# Access Compliance Report

## Public Rights-of-Way

Intersection ID: 4945	Main Street: LAWNMEADOW_DR	Cross Street: REAMES_RD	Location: SW
ADA ID: 314CB6F70485	Ramp Type: PerpDiag	Initial Pass/Fail: Fail	Overall Compliance: No
			Severity Score: 46.25

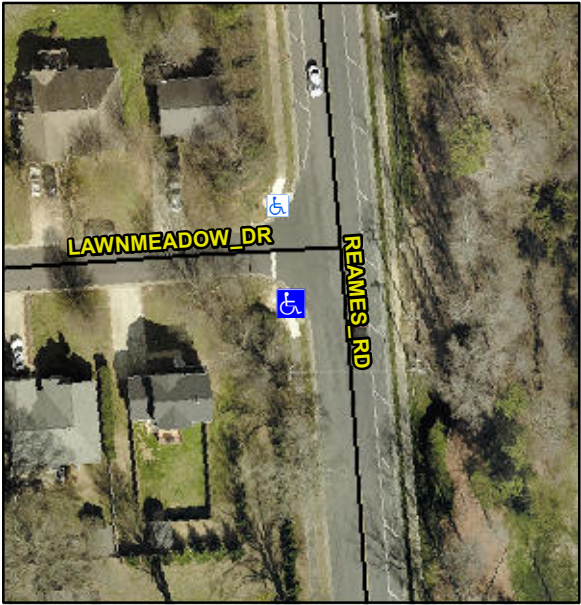
Codes/Mitigation Info/Possible Solution		Field Measurements/Component Compliance			
	Possible Solutions:				
	<b>Remove &amp; Replace Curb Ramp With Two New Directional Ramps or Equivalent.</b>				
	Surveyor Notes:				
	<b>N/A</b>				
	PROW/ADA:				
	<b>Not Found, R304.5.1, R304.2.2, R304.5.3</b>				
Street 1 Name	REAMES RD				
Stop Condition-Street 2	None				
Street 2 Name	LAWNMEADOW DR				
Stop Condition-Street 1	StopSign				
Total Cost:		\$	3200.00

Compliance	Description	Data	Compliance	Description	Data
N/A	Ramp Length (in)	49.5	No	Ramp Slope (%)	8.6
No	Ramp Width (in)	41.0	No	Ramp XSlope (%)	9.8
N/A	Flare Type LT	N/A	N/A	Flare Type RT	N/A
N/A	Flare Slope LT (%)	N/A	N/A	Flare Slope RT (%)	N/A
N/A	Flare Traversable LT?	N/A	N/A	Flare Traversable RT?	N/A
N/A	Landing Length (in)	N/A	N/A	DWS Provided?	N/A
N/A	Landing Width (in)	N/A	N/A	DWS Contrast?	N/A
N/A	Landing Slope (%)	N/A	N/A	DWS Length (in)	N/A
N/A	Landing X Slope (%)	N/A	N/A	DWS Full Width?	N/A
N/A	Landing Curb? (Y/N)	N/A	N/A	DWS Offset (in)	N/A
N/A	Shared Landing?	N/A			
N/A	Gutter Ponding?	N/A	N/A	Gutter Slope (%)	N/A
N/A	Gutter Lip Ht (in)	N/A	N/A	Gutter X Slope (%)	N/A
N/A	Painted X Walk1?	No	N/A	Painted X Walk2?	No
	X Walk 1 Direction	To E		X Walk 2 Direction	To N
N/A	X Walk 1 Width (in)	N/A	N/A	X Walk 2 Width (in)	N/A
	X Walk 1 Slope (%)	4.0		X Walk 2 Slope (%)	4.2
	X Walk 1 X Slope (%)	6.4		X Walk 2 X Slope (%)	3.6
